Transmit Jitter Requirements for 5G and 2.5GBASE-T

Hossein Sedarat

November 2015

Jitter and Sampling Error

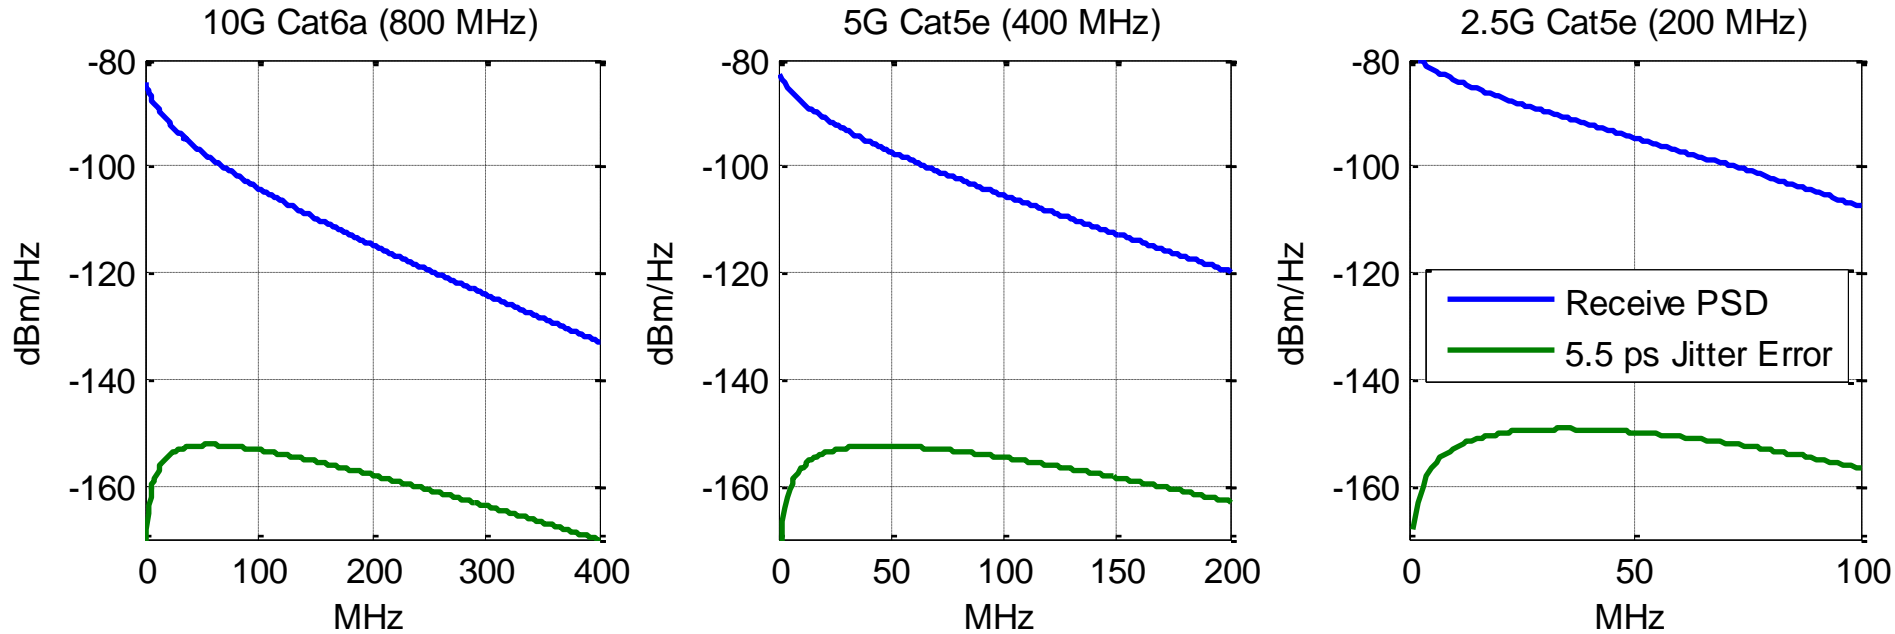
- Timing jitter of a remote transmitter causes sampling phase error at the local receiver which contributes to overall receiver noise
- There may be some other reasons to limit the timing jitter but only the factors that affect interoperability are considered in IEEE specifications
- The noise due to phase error
 - Is higher when the timing jitter is bigger
 - Grows linearly in frequency
 - Is higher when the signaling bandwidth is wider
